Work Order ID 141883

Item Name: Baggage Compartment Protector - Wall

DART SERVICE INSTRUCTION

TO AMEND INSTALLATION INSTRUCTIONS IIN-D407-781-2 REV. A OR LATER APPROVED REVISION
AND INSTRUCTIONS FOR CONTINUED AIRWORTHINESS ICA-D407-781 REV. 3 OR LATER REVISION

**FIGURE 1 - D3879-1 BAGGAGE COMPARTMENT WALL
PROTECTOR - ALTERNATE INSTALLATION**

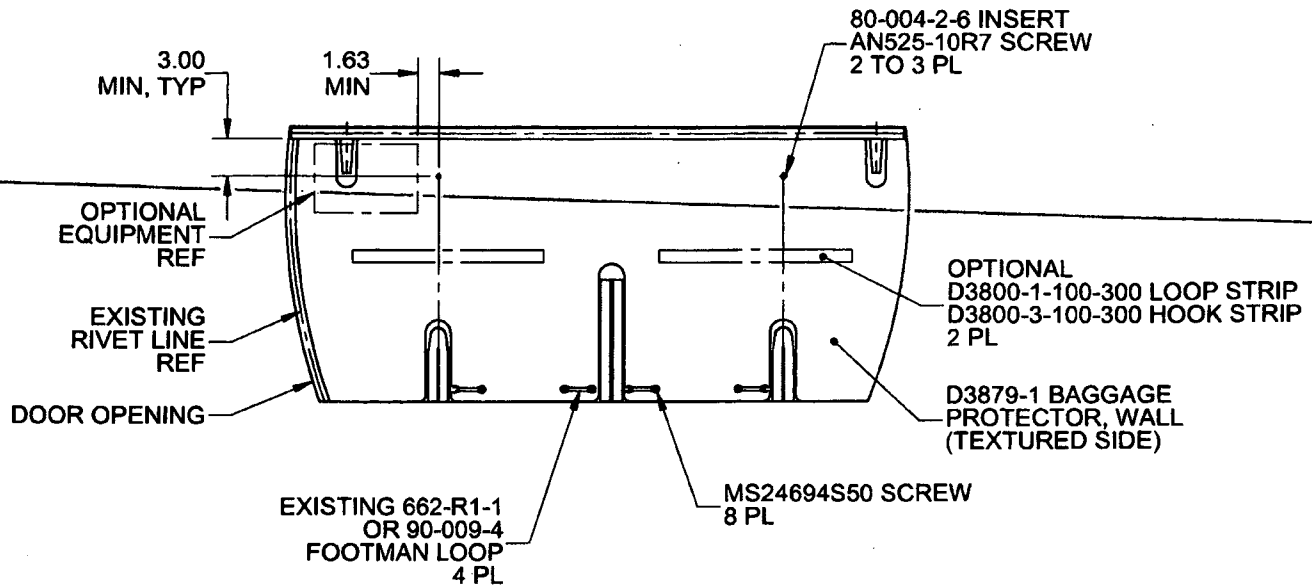
In some aircraft, the top portion of the D206-781-041 Baggage Compartment Wall Protector Kit cannot be installed as indicated in IIN-D407-781-2. The purpose of this DSI is to provide an alternate mounting method to fasten the top portion of the D206-781-041 Baggage Compartment Wall Protector Kit.

It is acceptable to replace qty(2) D3930-1 Clips with qty(2) 80-004-2-6 Inserts. Locate and mark location of the two attachment holes on the baggage compartment wall as shown in Figure 1 of this service instruction. Install 80-004-2-6 Inserts at the marked locations in accordance with Section 3-2-12 of BHT-206-SRM-1. It is acceptable to trim the wall protectors to accommodate optional equipment or transfer attachment holes to the wall protector and install the optional equipment on top of the wall protector with longer fasteners.

Qty -061	Qty -031	Qty -041	Part Number	Description
X			D206-781-061	BAGGAGE COMPARTMENT PROTECTOR KIT (FLOOR AND WALL)
1	X		D206-781-031	BAGGAGE COMPARTMENT FLOOR PROTECTOR KIT
1		X	D206-781-041	BAGGAGE COMPARTMENT WALL PROTECTOR KIT
		2	AN525-10R7	SCREW
		2	80-004-2-6	INSERT
